STATE OF MAINE
DEPARTMENT OF TRANSPORTATION
16 STATE HOUSE STATION
AUGUSTA, MAINE 04333-0016

December 29, 2022
Subject: Acadia Gateway
State WIN: 017163.03
Location: Trenton
Amendment No. 3

ACADIA GATEWAY FACILITY

INTERMODAL AND WELCOME CENTER

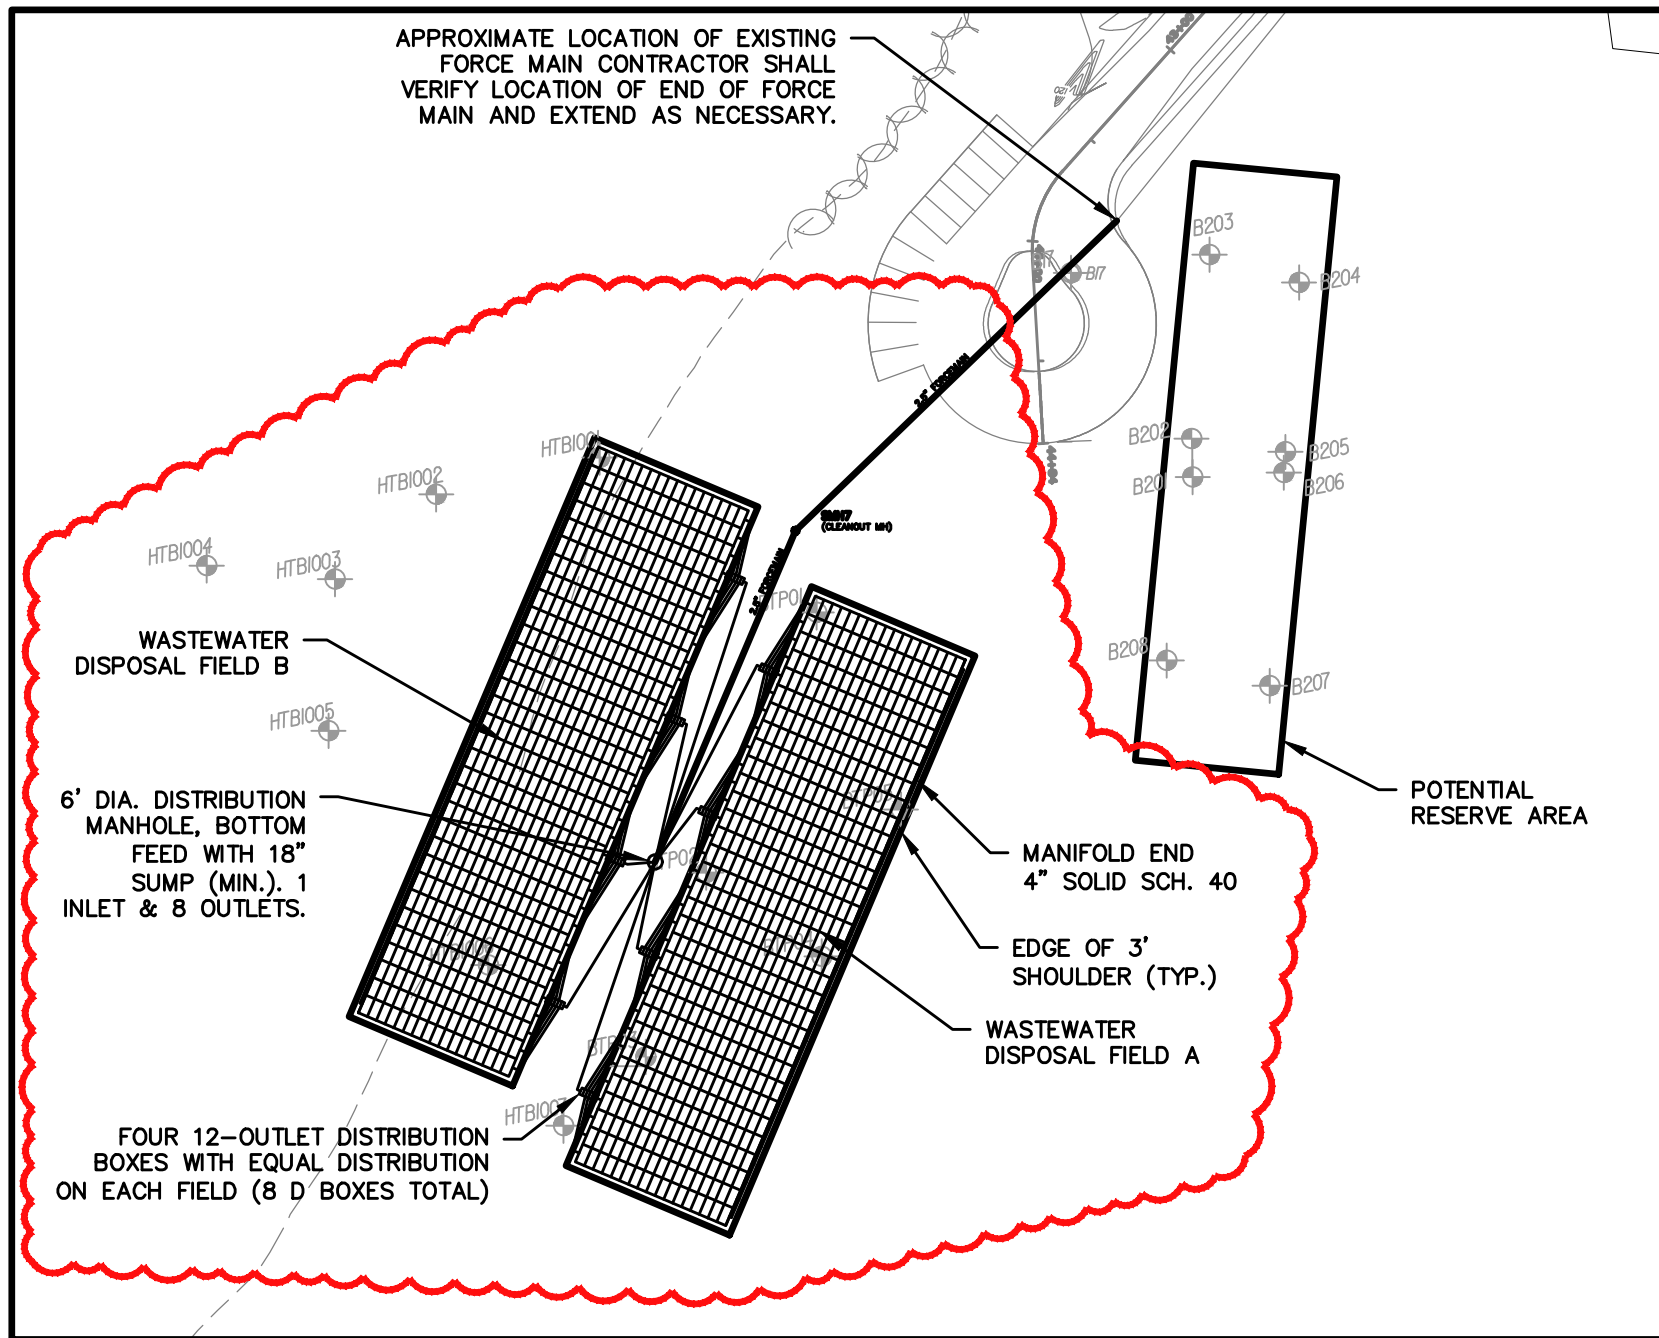
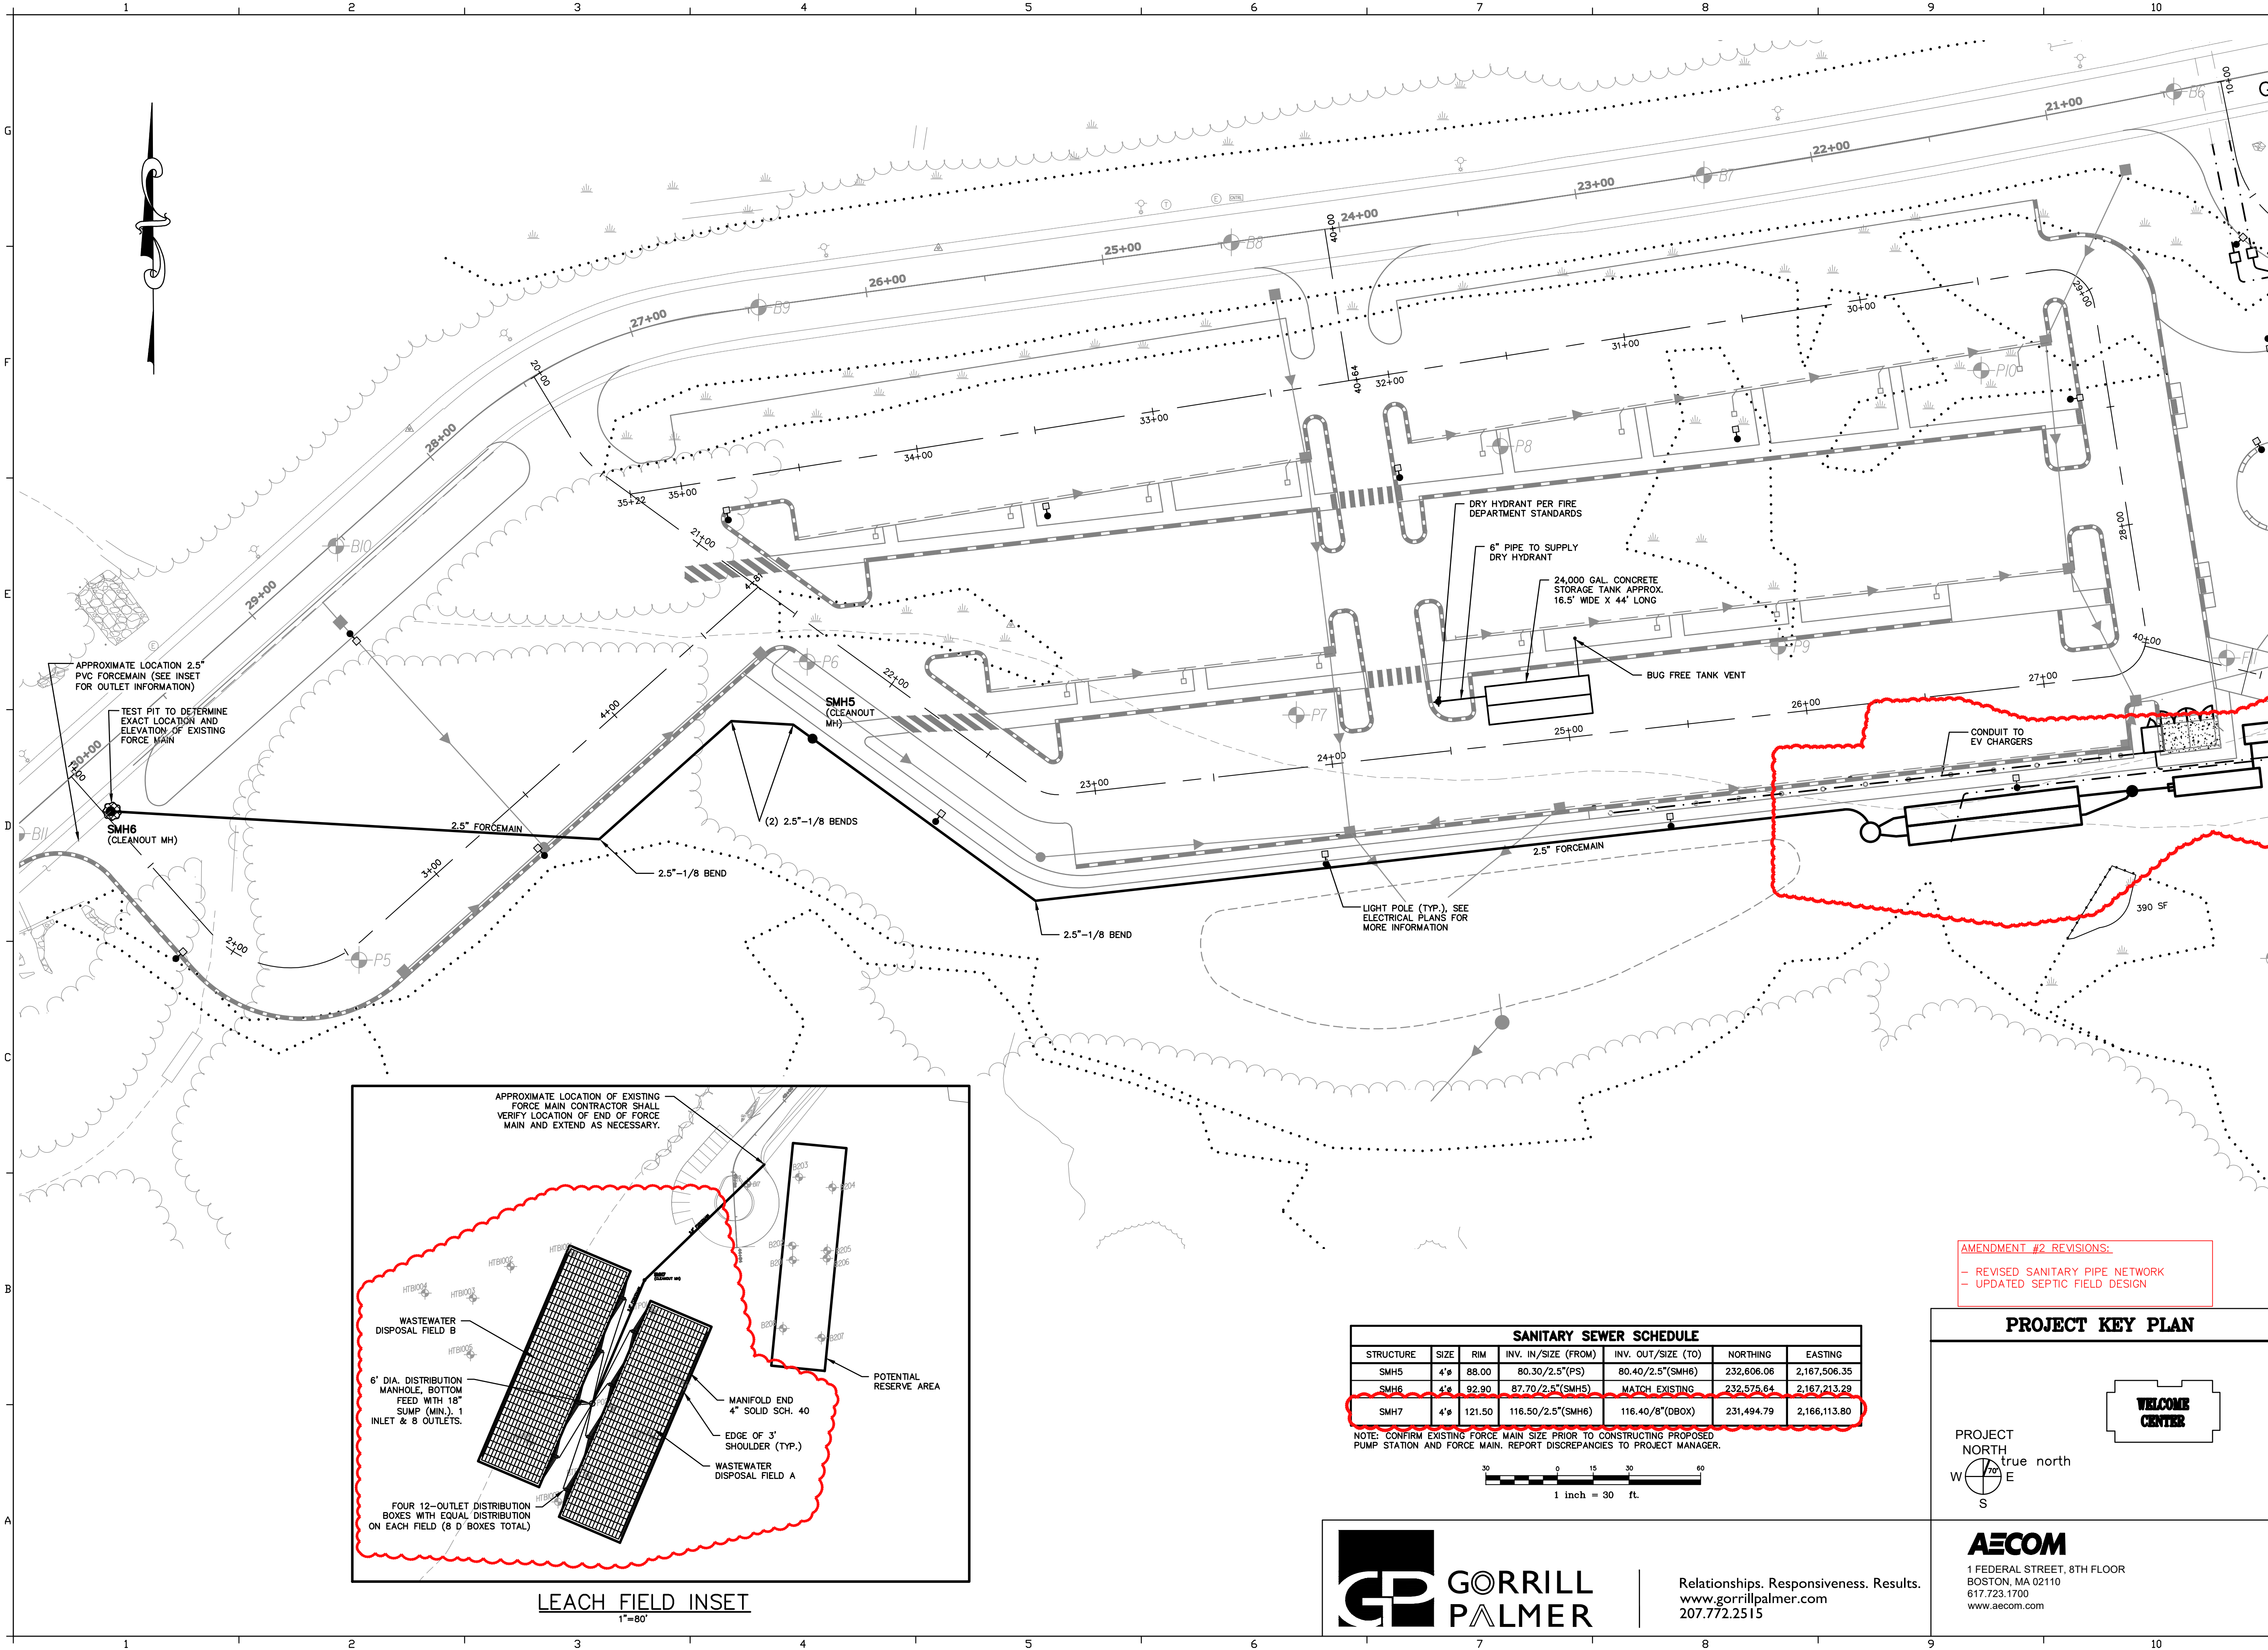
AMENDMENT #2 REVISIONS:
 - REVISED SANITARY PIPE NETWORK
 - UPDATED SEPTIC FIELD DESIGN

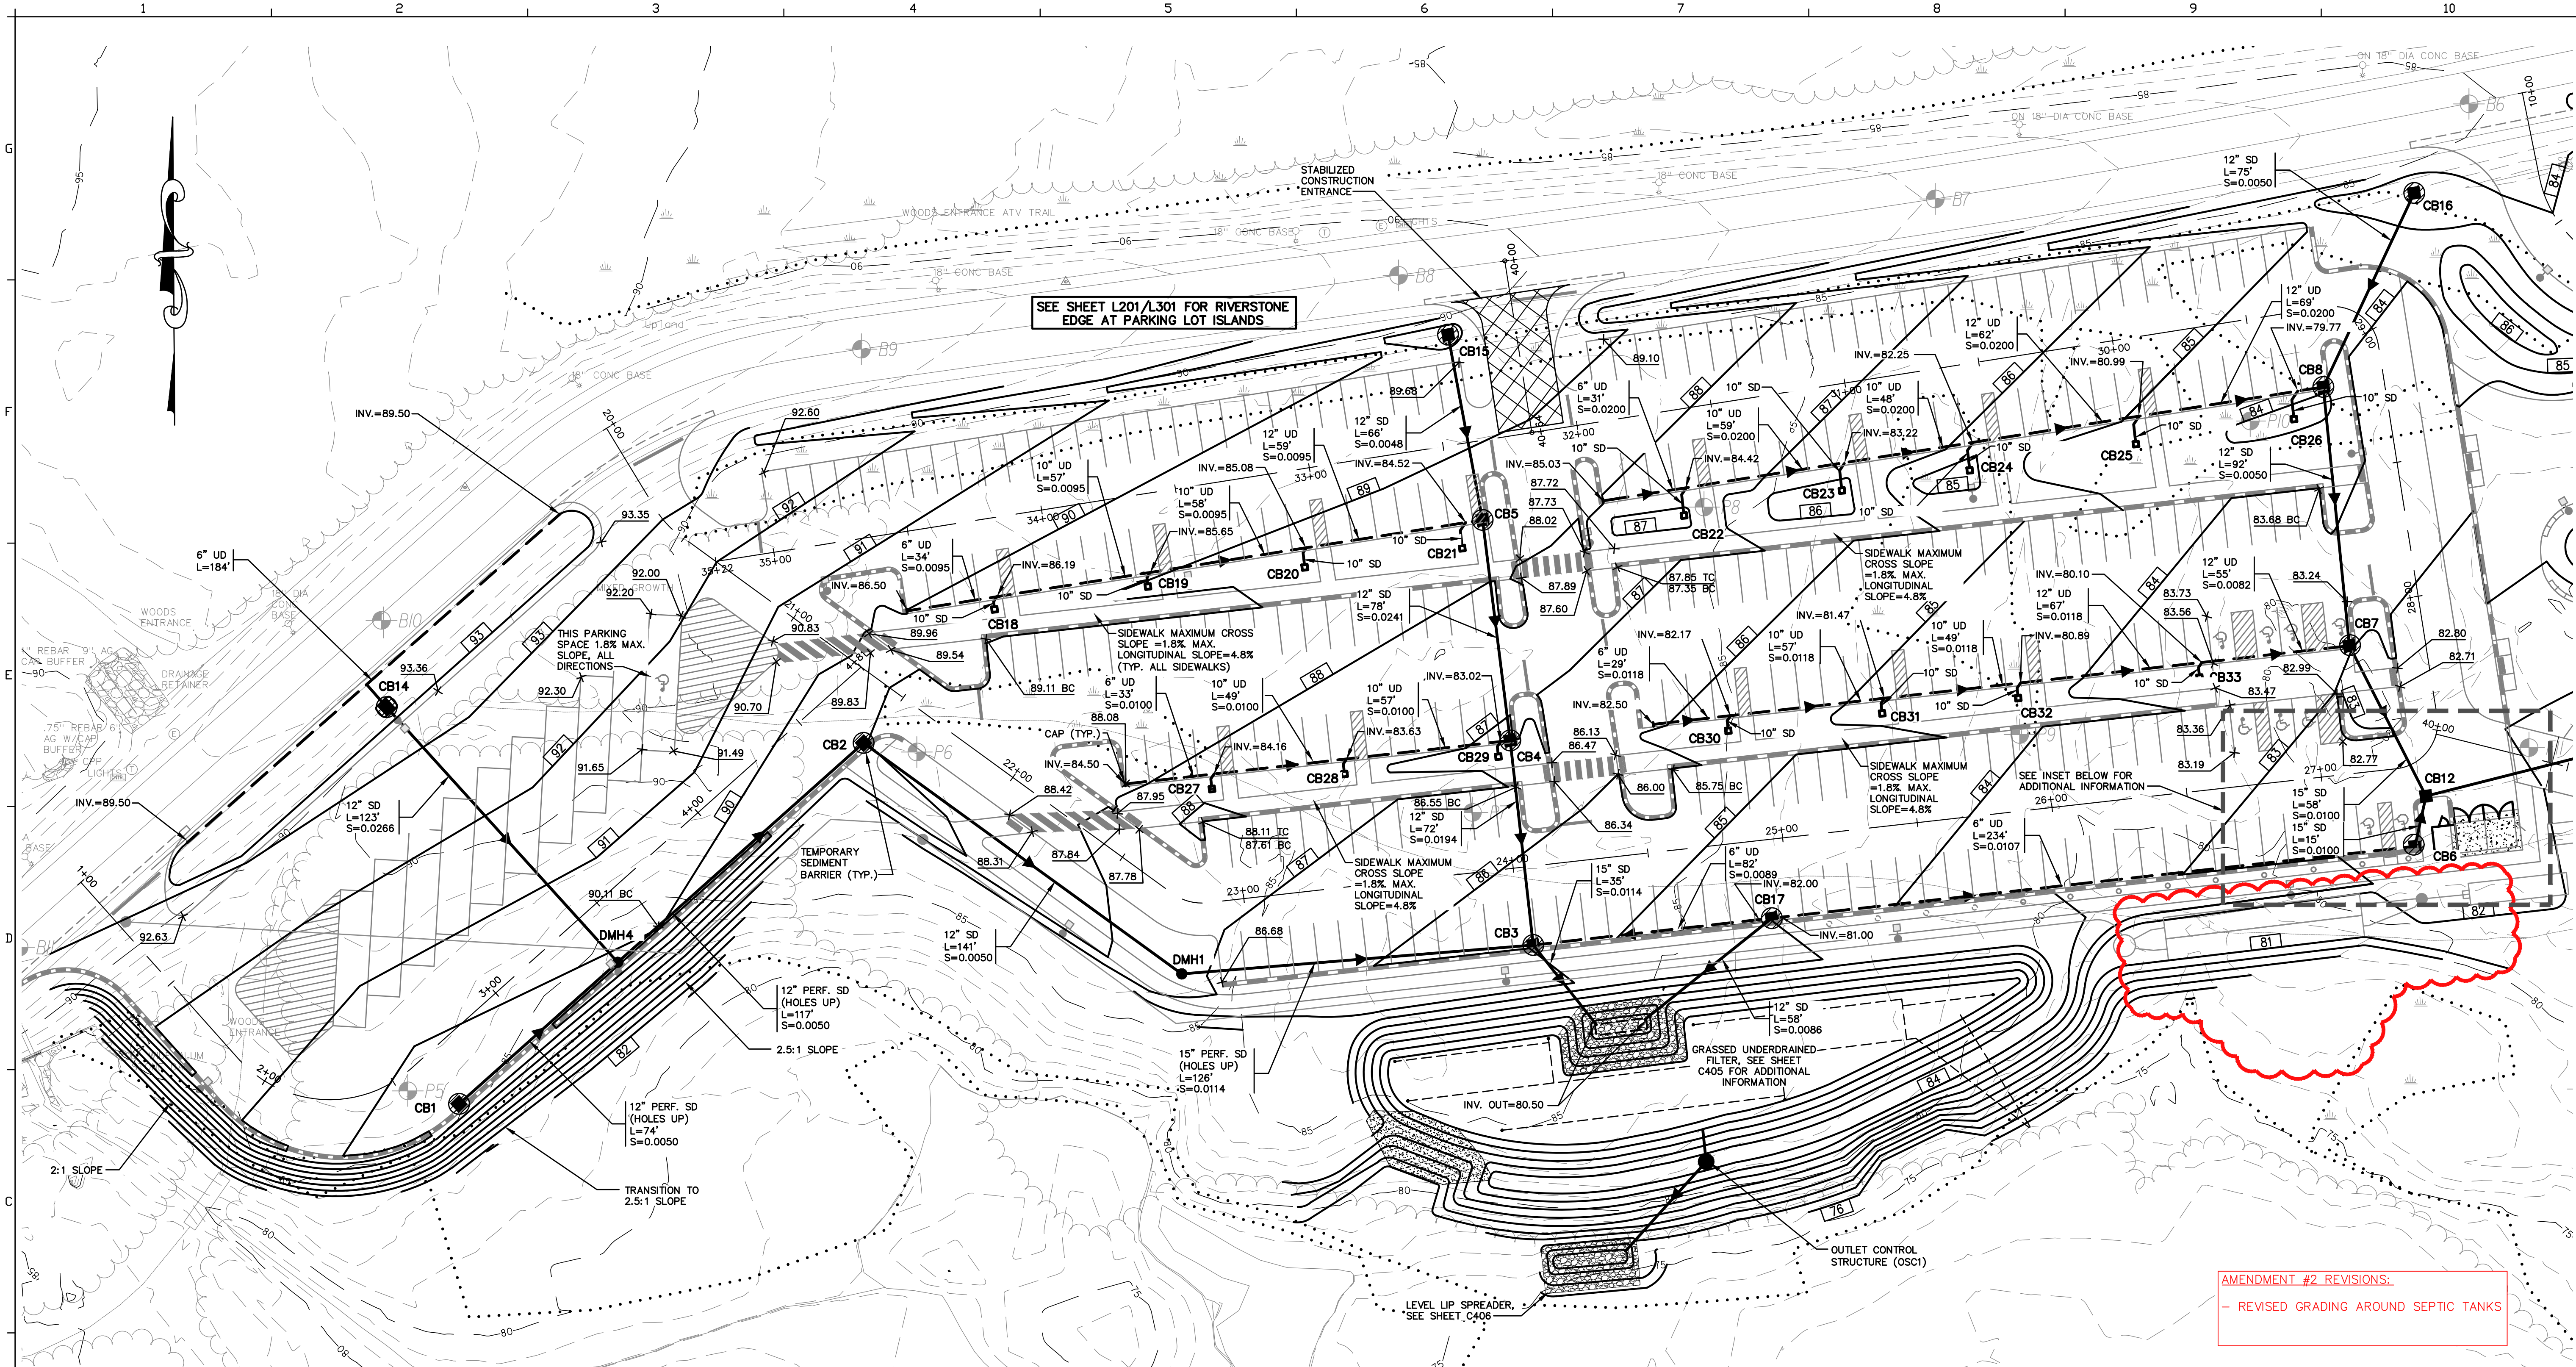
AMENDMENT #2 REVISIONS:
- REVISED GRADING AROUND SEPTIC TANKS
